Distributor & Dealer
Organization

No. A /187

PETROL TANK

SEVEN

IMPORTANCE OF CORRECT CLUTCH OPERATION

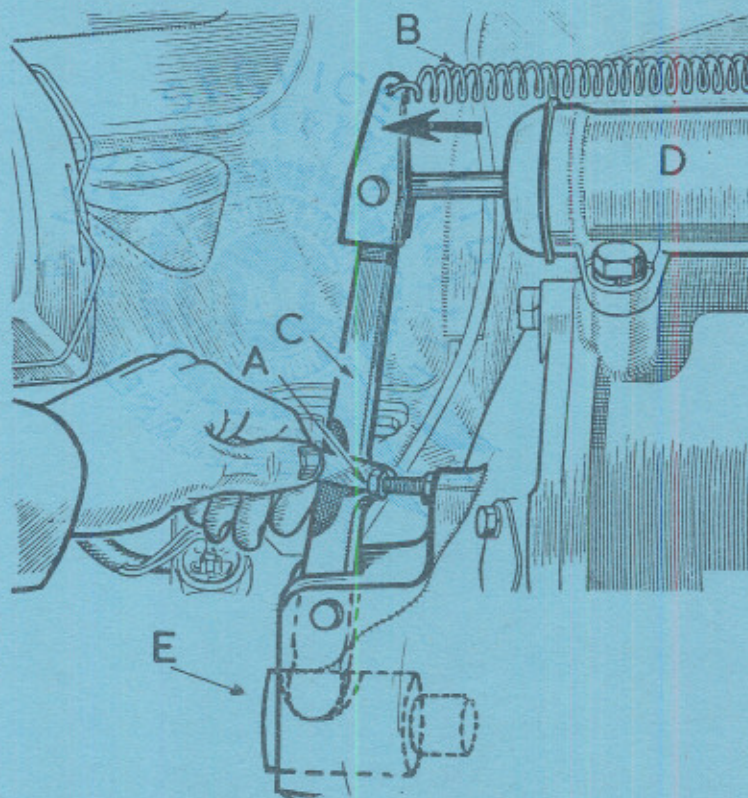
The design calls for only sufficient throw to free the driven plate and the requisite amount is regulated by the adjustable stop 'A'. The clearance here is normally .060" (1.52 mm.) - this is the MINIMUM permissible - but it may be increased to a MAXIMUM of .075" (1.91 mm.) as described later.

- (1) Stiffness in the operating mechanism, resulting in failure of spring 'B' (Part No. 22A5) to return lever 'C' to stop 'A'. (This means in effect that the clearance given at 'A' will be ADDED to the travel of the piston in slave cylinder 'D' on the subsequent operation of the clutch and overthrow will consequently take place)
- (2) Clutch pressure springs, Part No. 22A6, not to specification, with the result that they become coil-bound in normal clutch operation.

To counteract (1), a stronger spring, Part No. 1G5999, is now fitted in production and, as regards (2), a must closer inspection has been imposed.

(a) Warm up engine and allow to tick over at a speed not exceeding 500 r.m.p. Depress clutch pedal and release normally, repeating these operations three or four times without pause. If engine slows down appreciably or ultimately stalls, change spring 'B' for Part No. 1G5999 and repeat test.

(b) If the slowing-down and stalling still occur, the clutch pressure springs are suspect, as in (2) overleaf, and the effect of increasing the clearance at 'A' to the MAXIMUM of .075" (1.91mm.) should be tried.

(c) Should this prove of no avail, it will be necessary to fit a new set of clutch springs (see Note (i) below).

Overthrow due to stiffness - (1) overleaf - will almost certainly be overcome by the substitution of the stronger spring 1G5999. At the same time, any obvious causes of stiffness - e.g., a partial seizure of the throw-out plunger at 'E' or stickiness at this point due to an excess of paint, should naturally be dealt with.

Future production will have a modified slave cylinder piston cup, Part No. 17H7868. This provides much less frictional resistance than the present cup, Part No. 7H7923, which it will supersede for all service replacements. A limited quantity of the new cup is already available and stocks may be ordered in the normal way.

ADDITIONAL WEATHER-PROOFING PRECAUTIONS

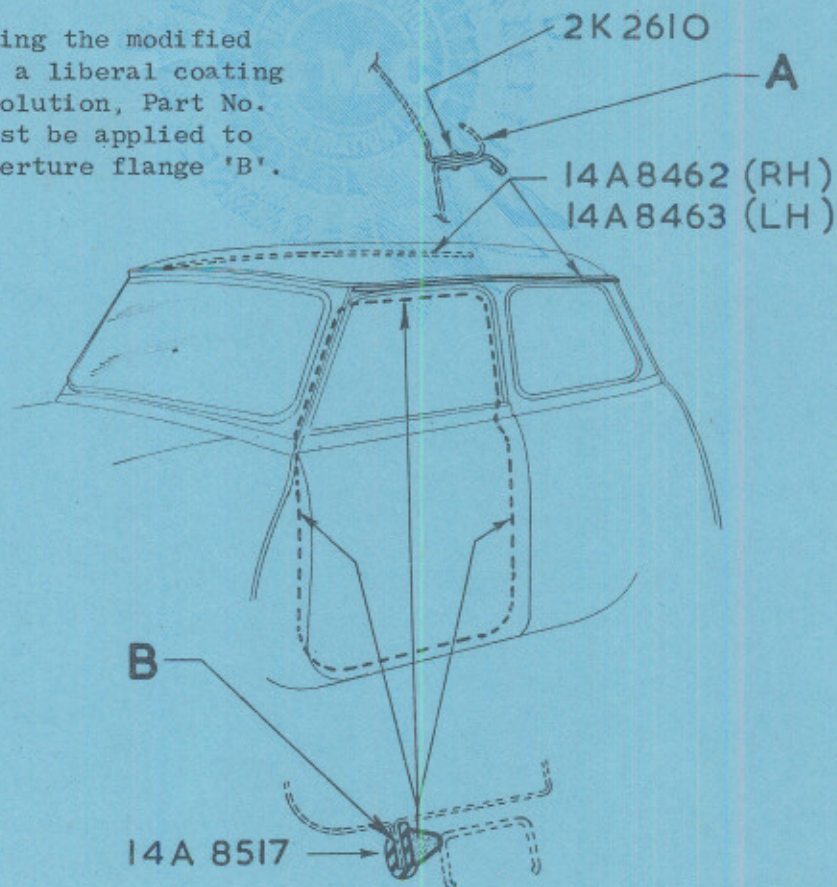
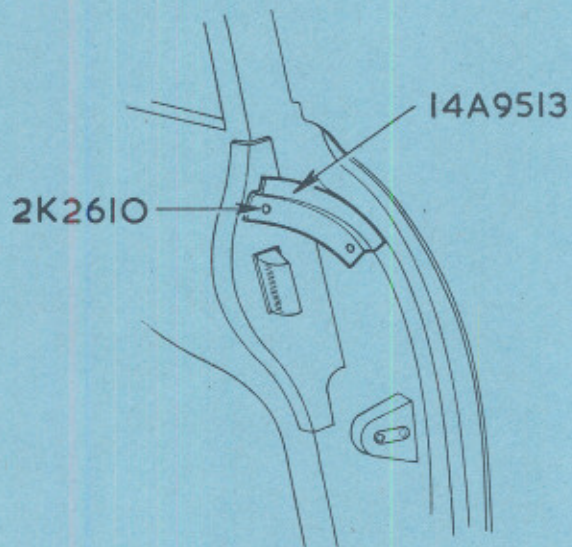
Under exceptionally wet conditions, the following parts (now available from B.M.C. Service Ltd.) should be fitted as extra to those specified in Service Journal A/165:

The drip mouldings are fitted below the existing moulding 'A' and are secured with "Pop" rivets, Part No. 2K2610 (10 each side). "G" clamps will facilitate drilling/riveting operations.

Before fitting the modified door seals, a liberal coating of rubber solution, Part No. 97H2556, must be applied to the door aperture flange 'B'.

The deflection plate is located by "Pop" rivets (2 off), Part No. 2K2610, and is positioned as shown below.

"Glastikon" caulking compound, Part No. 94938, must be applied under the plate, prior to fitting.

IMPORTANCE OF CORRECT CLUTCH OPERATION

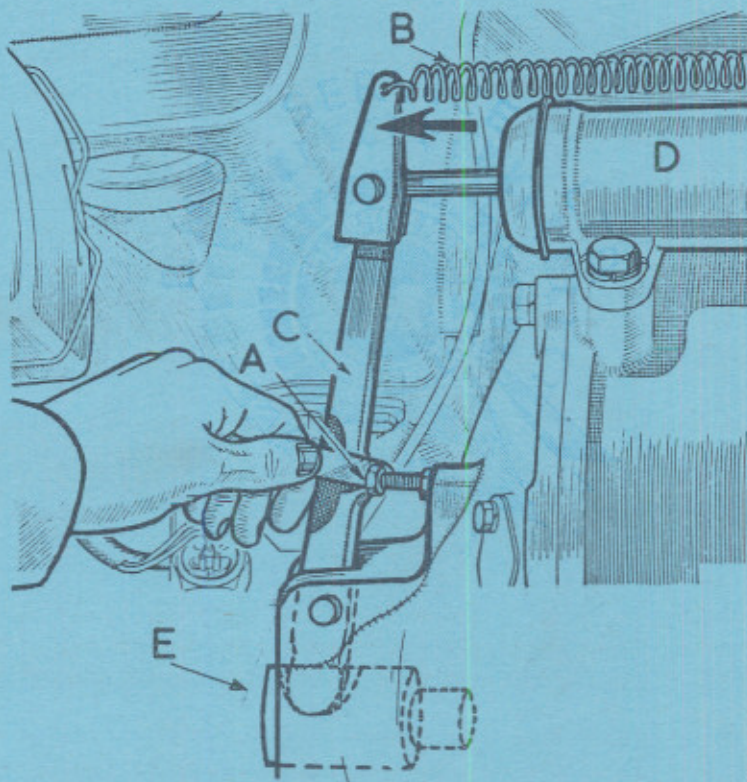
The design calls for only sufficient throw to free the driven plate and the requisite amount is regulated by the adjustable stop 'A'. The clearance here is normally .060" (1.52 mm.) - this is the MINIMUM permissible - but it may be increased to a MAXIMUM of .075" (1.91 mm.) as described later.

- (1) Stiffness in the operating mechanism, resulting in failure of spring 'B' (Part No. 22A5) to return lever 'C' to stop 'A'. (This means in effect that the clearance given at 'A' will be ADDED to the travel of the piston in slave cylinder 'D' on the subsequent operation of the clutch and overthrow will consequently take place);
- (2) Clutch pressure springs, Part No. 22A6, not to specification, with the result that they become coil-bound in normal clutch operation.

To counteract (1), a stronger spring, Part No. 1G5999, is now fitted in production and, as regards (2), a much closer inspection has been imposed.

* Identification of springs changed from blue to yellow.

(a) Warm up engine and allow to tick over at a speed not exceeding 500 r.p.m. Depress clutch pedal and release normally, repeating these operations three or four times without pause. If engine slows down appreciably or ultimately stalls, change spring 'B' for Part No. 1G5999 and repeat test.

(b) If the slowing-down and stalling still occur, the clutch pressure springs are suspect, as in (2) overleaf, and the effect of increasing the clearance at 'A' to the MAXIMUM of .075" (1.91 mm.) should be tried.

(c) Should this prove of no avail, it will be necessary to fit a new set of clutch springs (See Note (i) below).

Overthrow due to stiffness - (1) overleaf --will almost certainly be overcome by the substitution of the stronger spring 1G5999. At the same time, any obvious causes of stiffness --e.g., a partial seizure of the throw-out plunger at 'E' or stickiness at this point due to an excess of paint, should naturally be dealt with.

Future production will have a modified slave cylinder piston cup, Part No. 17H7868. This provides much less frictional resistance than the present cup, Part No. 7H7923, which it will supersede for all service replacements. A limited quantity of the new cup is already available and stocks may be ordered in the normal way.

SUSPENSION RUBBER SPRING COMPRESSOR

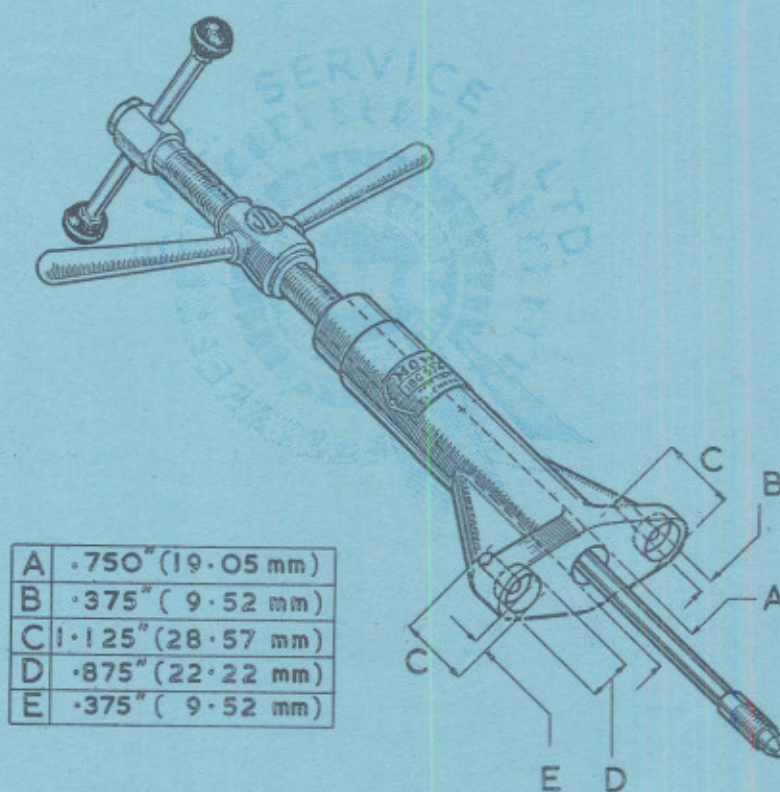
In order to provide for the alterations which have been made to the front sub-frame tower body fixing bolts and also improve the operation of the above tool, it should be modified to the dimensions indicated in the accompanying table.

A	.750" (19.05 mm)
B	.375" (9.52 mm)
C	1.125" (28.57 mm)
D	.875" (22.22 mm)
E	.375" (9.52 mm)

STEERING RACK BALL JOINT SPANNER & CLAMP

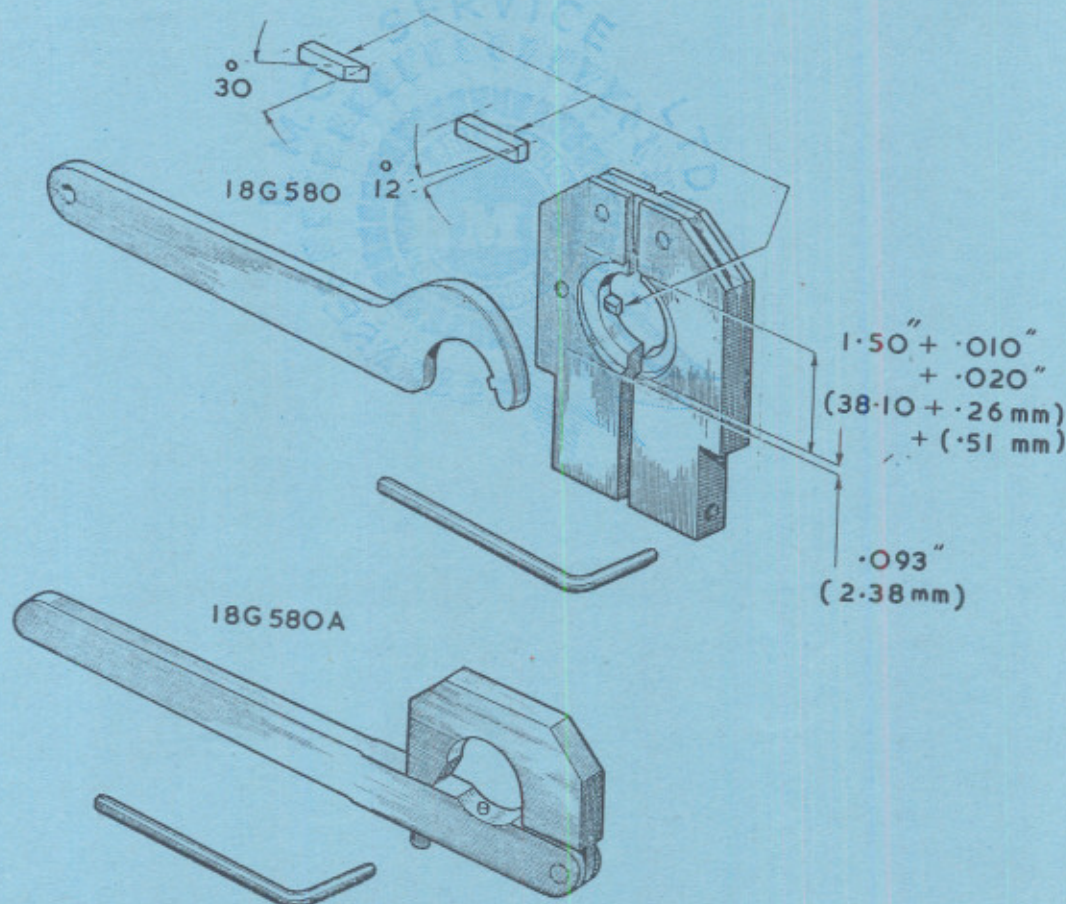
To accommodate all three types of ball joint in Service the clamp is now recessed as shown in sketch below. There is no change in Part No.

In dealing with the two later types of ball joint, this recess is essential as is also the new pin spanner and clamp key illustrated, Part No. 18G580A.

Original clamps already in Service must be modified by machining the recess to the dimensions indicated, concentric with the bore.

REAR TELESCOPIC SHOCK ABSORBER CONVERSION

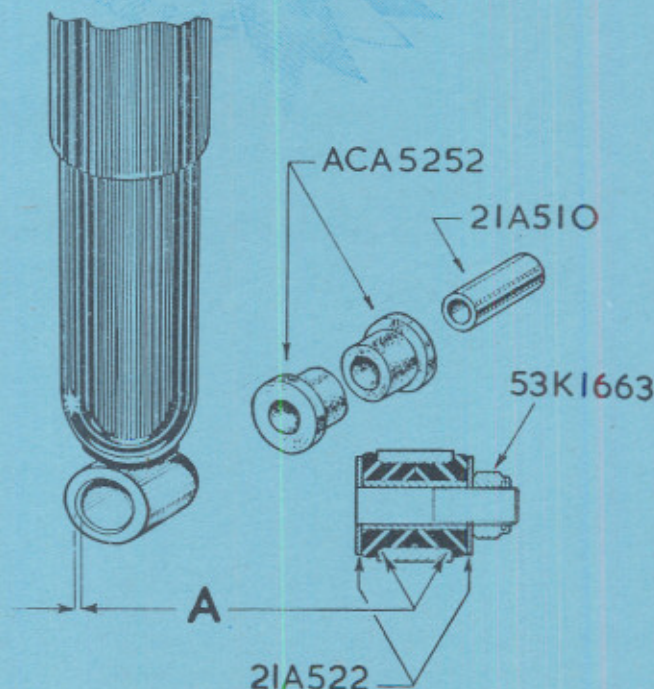
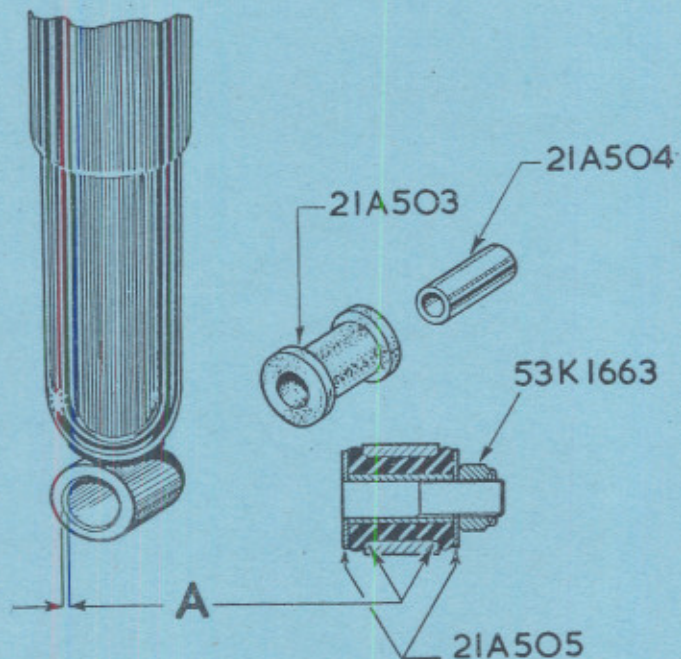
A more positive lower fixing may be provided in the event of failure of the standard arrangement. The improvement might also be conveniently made when the shock-absorbers are serviced:

Ensure that both sides of the damper eye at 'A' have a chamfer of .025" (.63 mm.) x 90° (Armstrong) or .046" (1.20 mm.) x 60° (Girling).

- (1) press out existing rubber bush
- (2) press in bushes, Part No. ACA5252
- (3) push in metal sleeve, Part No. 21A510
- (4) position metal retaining washers, Part No. 21A522
- (5) lock up nut, Part No. 53K1663.

- (1) press out existing bush
- (2) press in bush, Part No. 21A503
- (3) push in sleeve, Part No. 21A504
- (4) position metal retaining washers, Part No. 21A505
- (5) lock up nut, Part No. 53K1663.

FUEL TANK GAUGE UNIT - FLANGE CRACKED

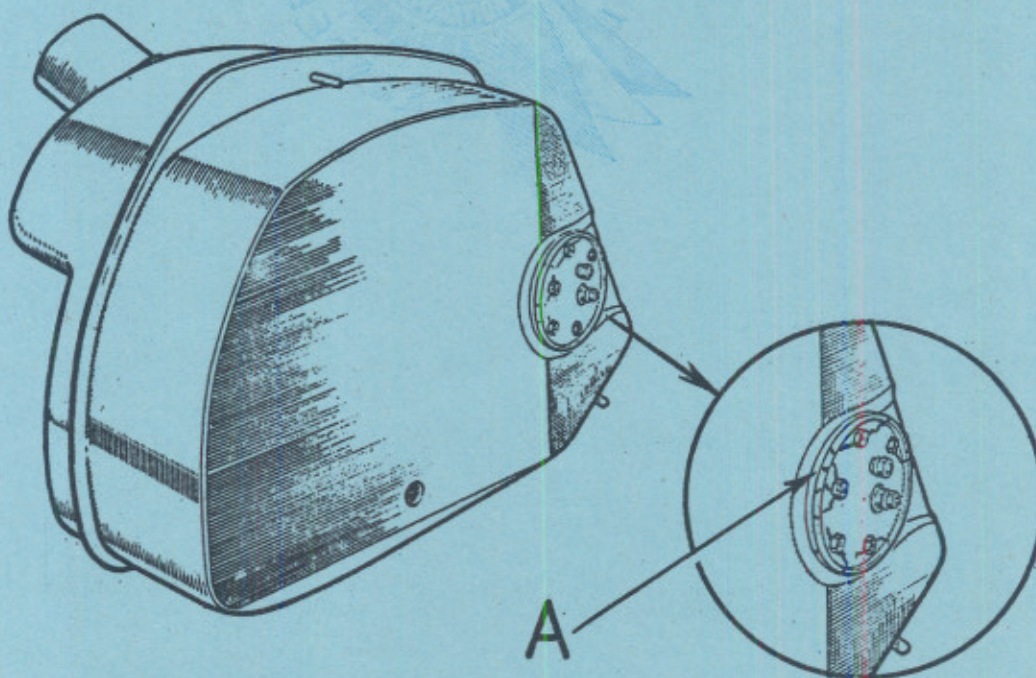
Over-tightening the fixing screws may lead to cracking of the flange at 'A'.

The gauge unit should be carefully inspected and replaced, if cracked, together with a new joint washer, Part No. 2H1082.

A suitable sealing compound (e.g. "Holdtite") should be used on both sides of the joint washer and also on the fixing screws which should be tightened evenly without excessive pressure.

FUEL TANK GAUGE UNIT - FLANGE CRACKED

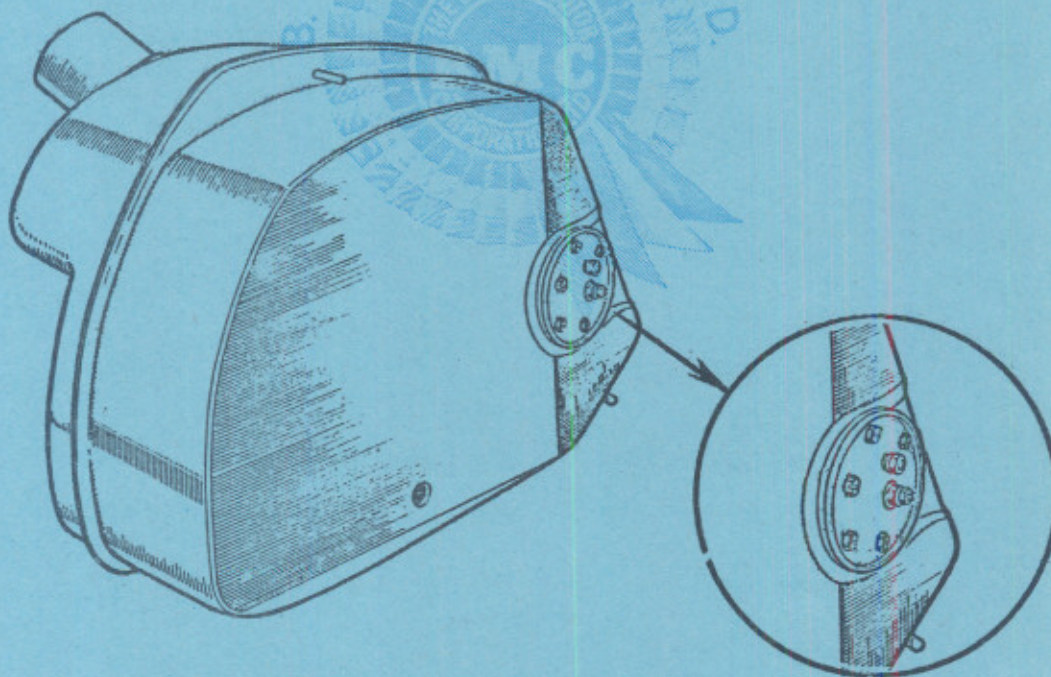
Over-tightening the fixing screws may lead to damage to the flange.

* effect of over-tightening amended.

The gauge unit should be carefully inspected and replaced, if damaged, together with a new joint washer, Part No. 2H1082.

A suitable sealing compound (e.g. "Holdtite") should be used on both sides of the joint washer and also on the fixing screws which should be tightened evenly without excessive pressure.
